From: Hanson, Paul: PC-BlgCtrl [paul.hanson@rbkc.gov.uk]
Sent: 08/01/2014 15:06:14
To: Hoban, John: PC-BlgCtrl [john.hoban@rbkc.gov.uk]
Subject: RE: Grenfell Tower, Grenfell Road, Refurbishment - Fire Strategy P2

The Building Regulations 2010 [as amended]
Grenfell Tower, Grenfell Road. London. W11.

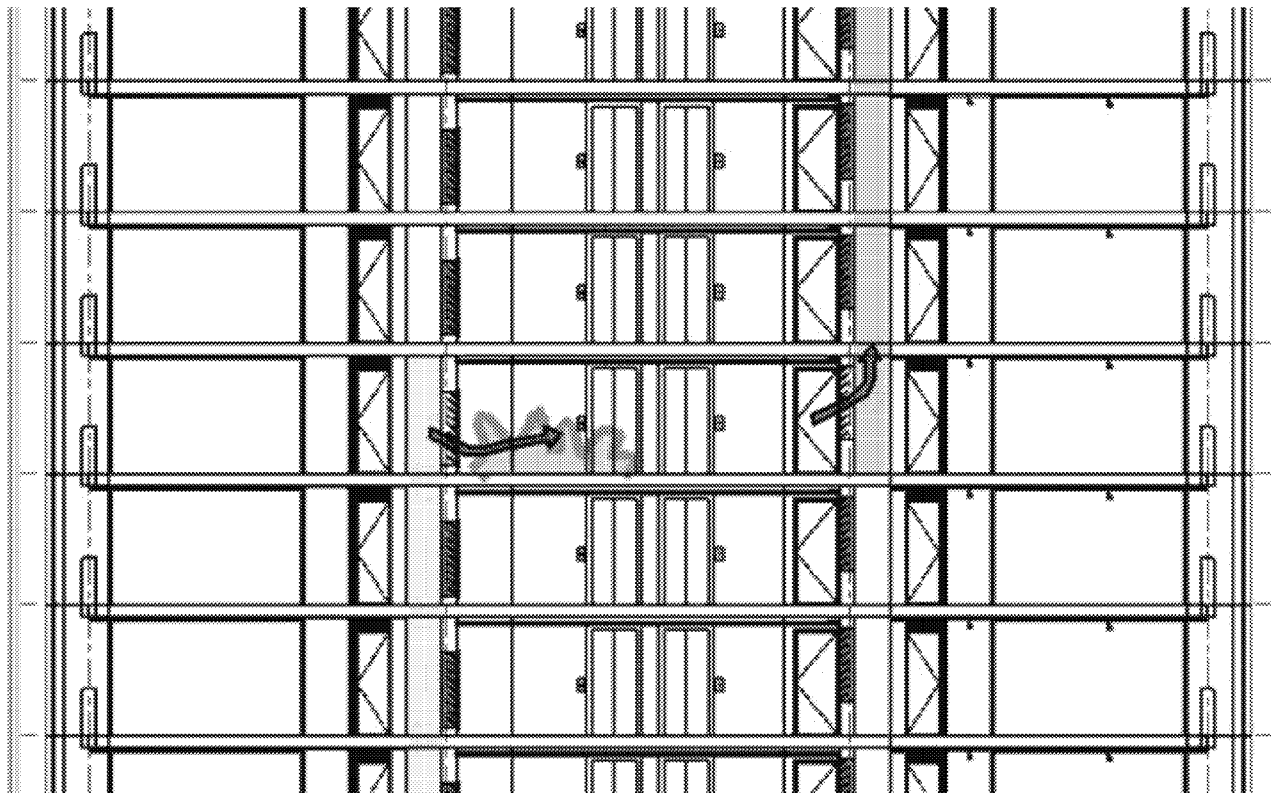
1. "...is designed .. as a natural ventilation system..." (line 2) is followed by "a mechanical supply and extract system which does not rely on natural ventilation" (Smoke Control, second para). His initial response is that this reads like we are omitting a compliant natural vent shaft. We could just leave the 'compliant' system as it is at present, but we (and Exova) think it would be better to provide a more predictable system with mechanical supply and extract as the default mode, all as described in the 'Proposed System' part of our report.

2. Some diagrams would be useful. I have attached our schematic drawing and Studio E have provided the visual representation below.

3. Principle of dual use of duct for vent and smoke okay – but not clear from document and would like some detail as to how this will be achieved.

The smoke controls and the temperature controls would all be part of the same control system controlling the dampers and the supply and extract fans.

Under normal conditions, all the dampers would be open and the system would operate as a natural ventilation system. Temperature sensors would be located on 'typical' (say 5 No.) lobbies. If the temperature in any of these areas exceeded a pre-set comfort level, then the supply and extract fans would operate to try to reduce the temperature.

In the event of smoke being detected within any lift lobby served by the smoke control system, the fresh air and smoke dampers serving that particular lobby would remain open and the supply and extract fans would operate. The fresh air and smoke dampers on all other levels would be closed. The system would be set up such that it was 'fail-safe' with priority always being given to the fire safety operation.
